# UNITED STATES PATENT AND TRADEMARK OFFICE

APPLICATION NO.	FILING DATE	FIRST NAMED INVENTOR	ATTORNEY DOCKET NO.	CONFIRMATION NO.
10/574,617	04/05/2006	Naoto Yokoyama	0033-1073PUS1	2104

<b>Office Action Summary</b>	<b>Application No.</b> 10/574,617	<b>Applicant(s)</b> YOKOYAMA ET AL.	
	<b>Examiner</b> CHARLES CHANG	<b>Art Unit</b> 2881

**FIG. 2**

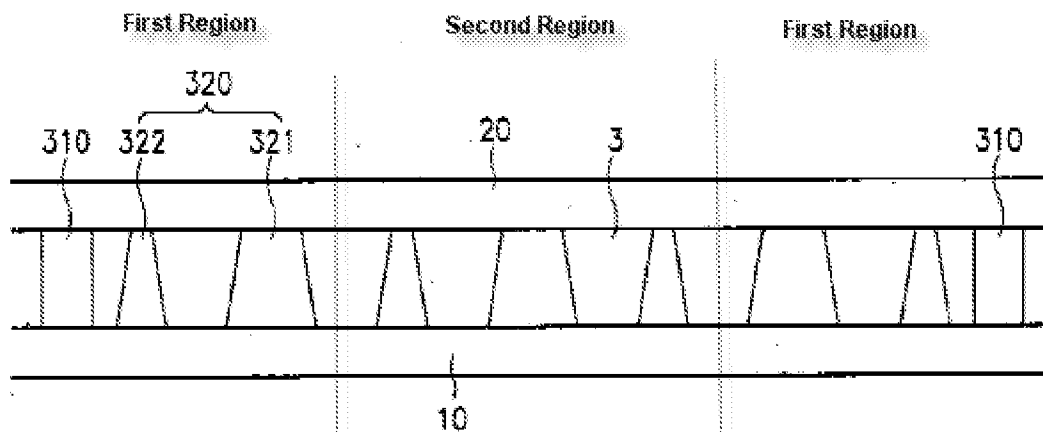
3. Claim 4 is rejected under 35 U.S.C. 102(e) as being anticipated by Cho et al. (US 20040114087).

Regarding claim 4, Cho discloses a liquid crystal display panel comprising: two substrates (10, 20) fixed together by a seal member (310) with their main surfaces opposed to each other; liquid crystal (3) sealingly stored in a region surrounded by said two substrates and said seal member and a plurality of columnar spacers (320) arranged in the region surrounded by said two substrates and said seal member, wherein said columnar spacers include: a first columnar spacer (321), and a second columnar spacer (322) being higher than said first columnar spacer when receiving no load; said first columnar spacer is arranged in a first region near an inner side of said seal member and a second region located inside said first region; and said second columnar spacer is arranged in said second region (Fig. 2 below and Fig. 3).
